Docket Item #9 & #10
BAR CASE # 2016-0439 & 0440

BAR Meeting
January 18, 2017

ISSUE: Permit to Demolish/Capsulate and Certificate of Appropriateness for an Addition (skylights) and Alterations

LOCATION: 115 North Fairfax Street

Figure 5: Proposed bollard design

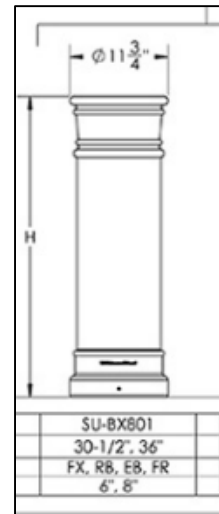
The *Design Guidelines* do not specifically address the design of bollards, but they do recommend that: “...above grade elements of a parking garage or lot such as fences, walls, gates, lights, signage and bollards and chains, should not detract from the architectural character of the surrounding buildings...” The applicant has indicated that for many years their property has been used illegally as a parking area by the public and by visitors to the adjacent bank. Efforts to stop the illegal parking have been unsuccessful, so two retractable bollards are now proposed. The black, cast aluminum bollards will measure 30” in height and 6” in diameter and can be controlled remotely by the building tenants. Although it’s unfortunate the applicant must install the bollards, staff believes that they will be minimally obtrusive and will not obscure views of the historic building or surroundings.
